PICO POWER PROJECT

Supplement in Response to Data Adequacy Comments

(02-AFC-03)

Silicon Valley Power

1. Gravel Pit Map (12-month process [Appendix B(g)(17)(C)]):

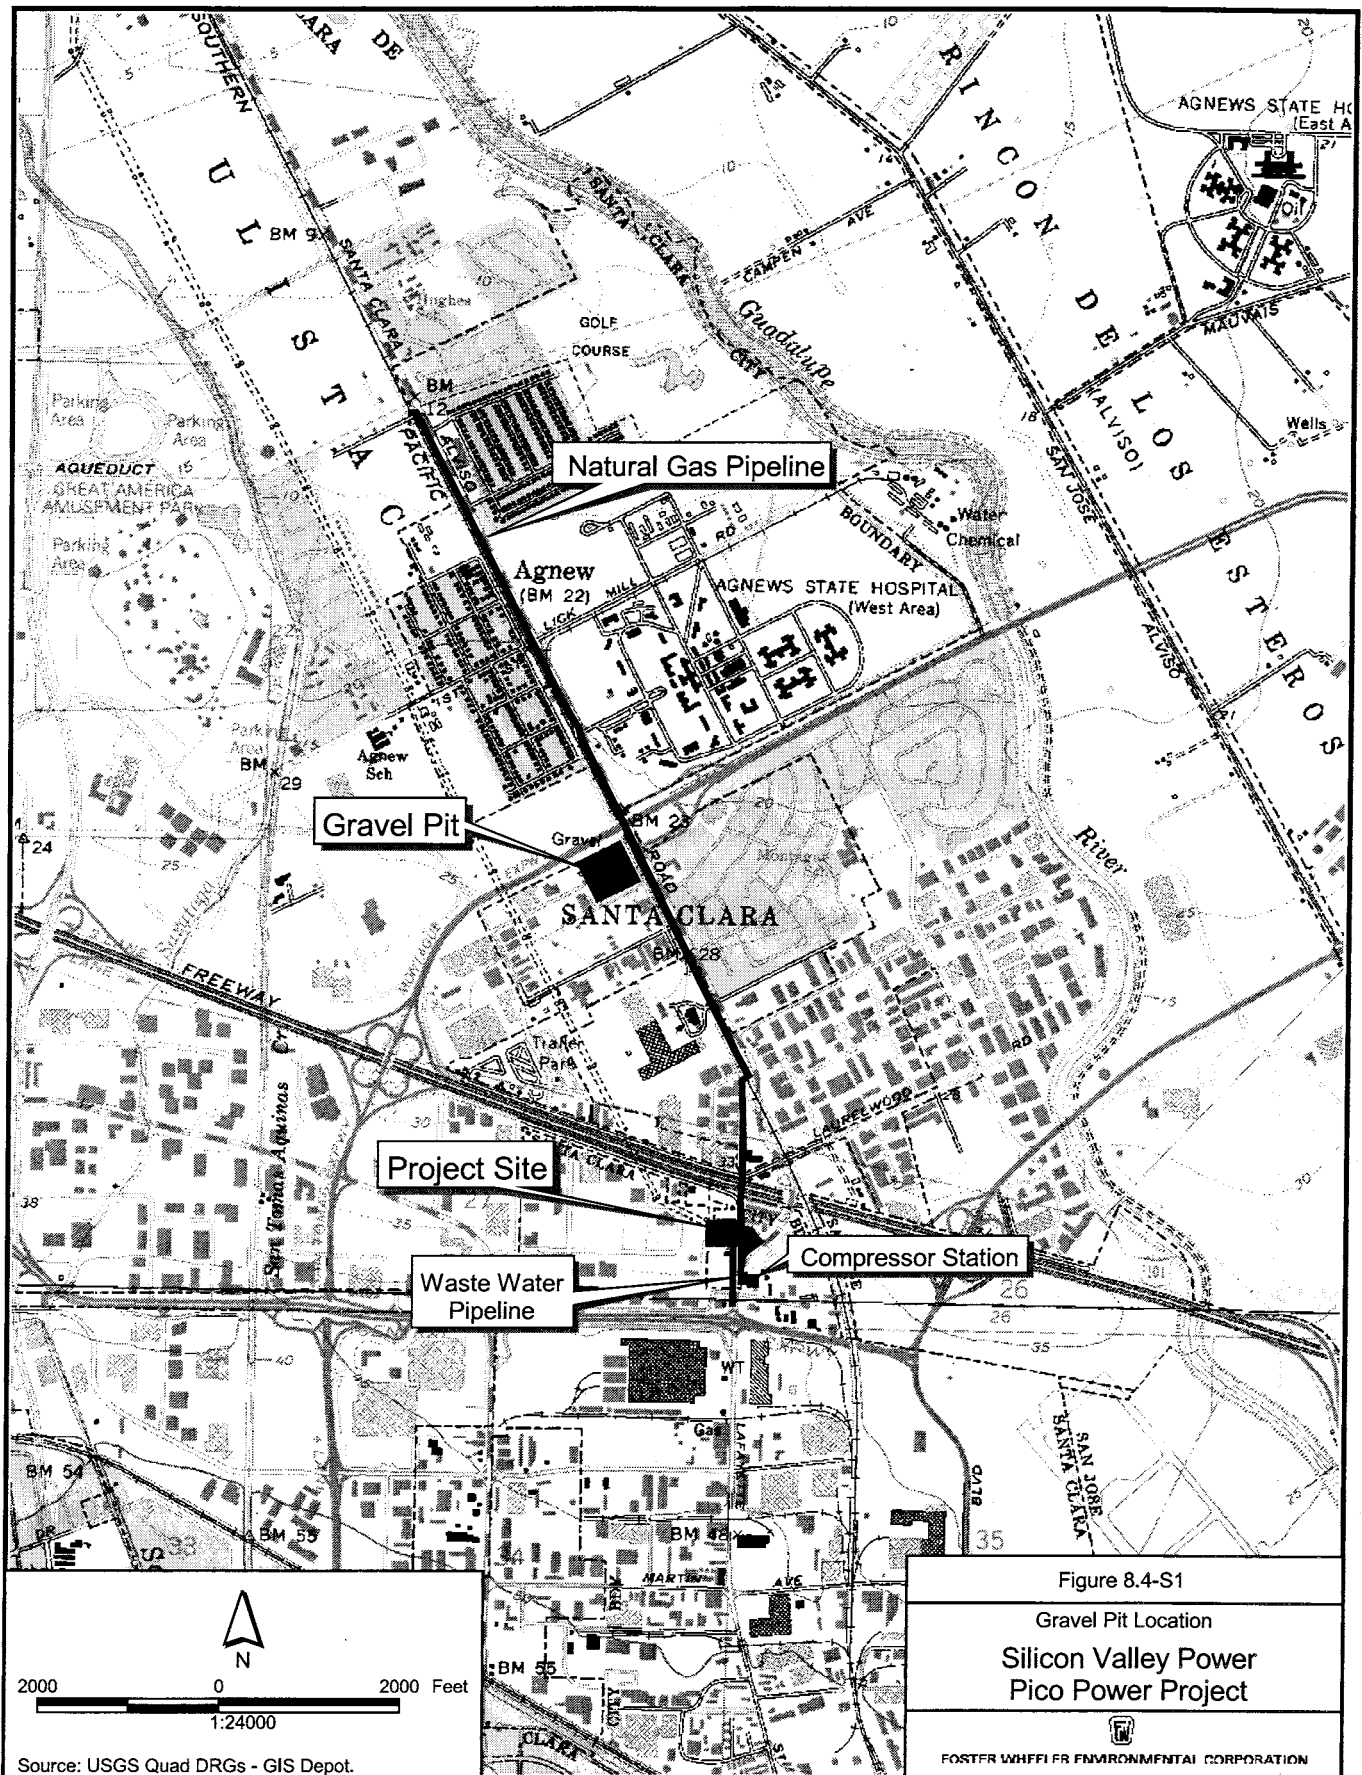
Provide a map showing the location of the gravel pit with respect to the project and associated linears.

Response—The gravel pit is located across the Union Pacific Railroad tracks and west of the Lafayette Street route of the natural gas pipeline route. The project would not affect this gravel pit or associated mineral resources, since the pipeline is located in a city roadway that is not available for gravel removal. The location of this gravel pit is shown in AFC Figure 8.4-1. Attached is Figure 8.4-S1 showing this location more clearly.
